- SUBJECT:
1. Environmental Determination (Exempt 15115)
 2. Tentative Map (P-9371)

LOCATION: 8900 Alder Avenue (southwest corner of Alder Avenue and Elk Grove-Florin Road)

RESOLUTION ADOPTING FINDINGS OF FACT, APPROVING
A REQUEST FOR TENTATIVE MAP FOR PROPERTY LOCATED
AT 8900 ALDER AVENUE (APN: 62-043-01) (P-9371)

TENTATIVE PARCEL MAP

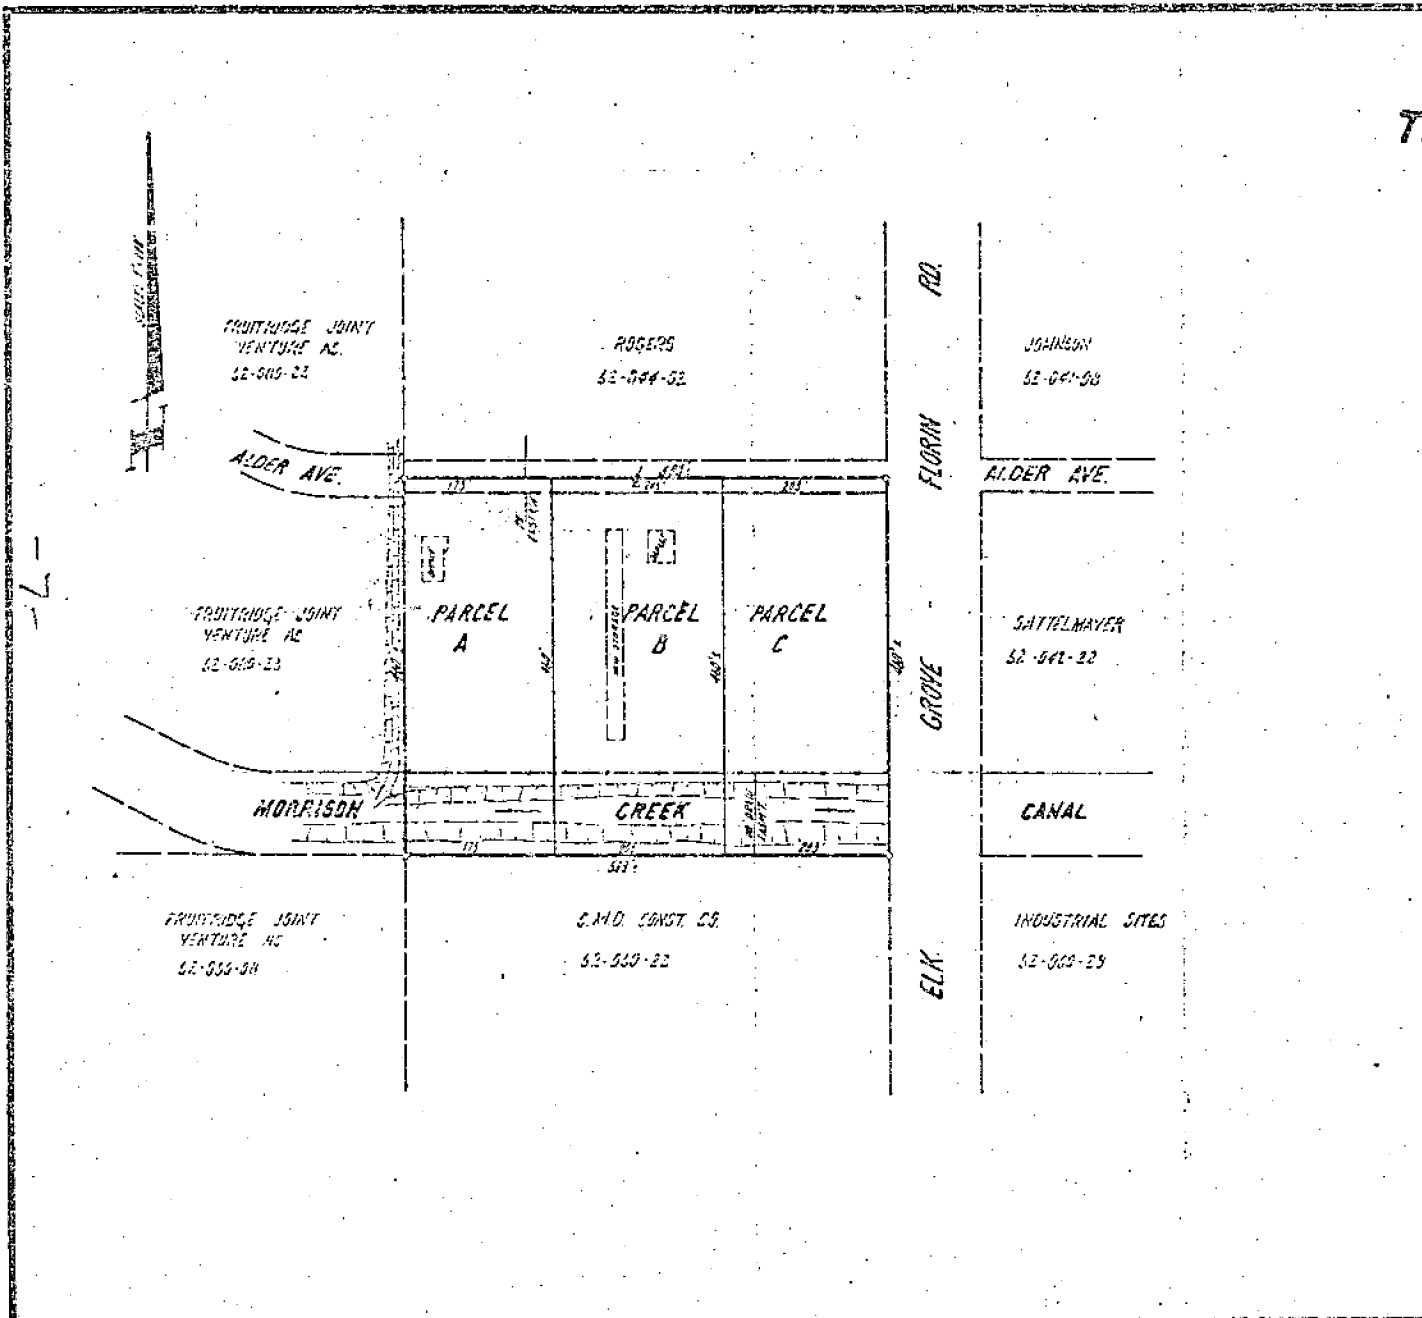
Staff has no objection to the proposal; however, it appears that the 25-foot setback along Alder Avenue has never been landscaped as required by the Zoning Ordinance. Staff therefore suggests the 25-foot front setback for Parcels A and B along Alder Avenue be landscaped and maintained. Landscaping on Parcel C frontage will be required when a building is constructed on the site.

1. The applicant shall provide standard subdivision improvements along Alder Avenue and Elk Grove/Florin Road pursuant to Section 40.811 of the Subdivision Ordinance prior to filing the final map.

2. The applicant shall prepare a sewer and drainage study for the review and approval of the City Engineer prior to filing the final map.
3. Applicant shall provide flood study to determine which portion is in flood channel area for review and approval of City Engineer.

4. A note shall be placed on final map for remaining property: "Fill must be placed over Parcels A, B, and C to elevation of 46.0 City Datum prior to development in order to protect from Morrison Creek flooding."

5. Applicant shall dedicate a 29-foot half-section along Alder Avenue and 25-foot radius round corner at Elk Grove/Florin Road. Also, slope easement at westerly channel crossing.

6. Applicant shall provide a 12-foot lane on north side of Alder Avenue and construct the bridge at the western property line.
7. Applicant shall pay one-eighth of the cost of the bridge construction over drainage channel.

8. Applicant shall dedicate a 55-foot half-section (or 60 feet if bikeway required) along Elk Grove/Florin Road with slope easement at Morrison Creek.
9. Applicant shall landscape the 25-foot setback area from property line along the Alder Avenue frontages for Parcels A and B in accordance with Zoning Ordinance. Landscape plan to be submitted for staff review and approval prior to final recordation of the map. Landscaping shall include a combination ground cover, trees and shrubs.

TENTATIVE PARCEL MAP

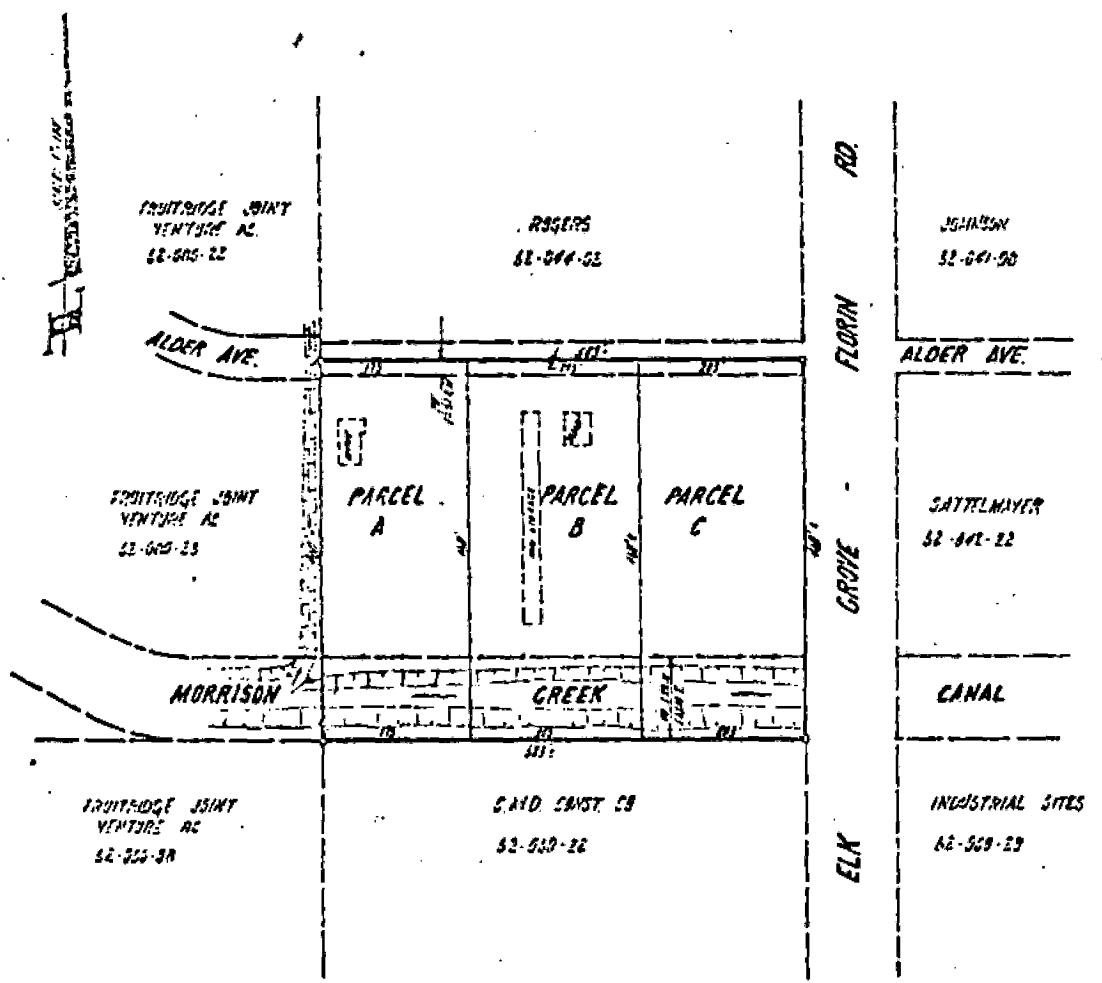
- 1. The applicant shall provide standard subdivision improvements along Alder Avenue and Elk Grove-Florin Road pursuant to Section 40.811 of the Subdivision Ordinance prior to filing the final map.
- 2. The applicant shall prepare a sewer and drainage study for the review and approval of the City Engineer prior to filing the final map.
- 3. The applicant shall provide flood study to determine which portion is in flood channel area for review and approval of the City Engineer.
- 4. The applicant shall dedicate a 29-foot half-section along Alder Avenue and 25-foot radius round corner at Elk Grove-Florin Road; also, slope easement at westerly channel crossing.
- 5. The applicant shall provide a 12-foot lane on north side of Alder Avenue and construct the bridge at the western property line.

6. The applicant shall pay one-eighth of the cost of the bridge construction over drainage channel.
7. The applicant shall landscape the 25-foot setback area from property line along the Alder Avenue frontages for Parcels A and B in accordance with Zoning Ordinance. Landscape plan to be submitted for staff review and approval prior to final recordation of the map. Landscaping shall include a combination of ground cover, trees, and shrubs.
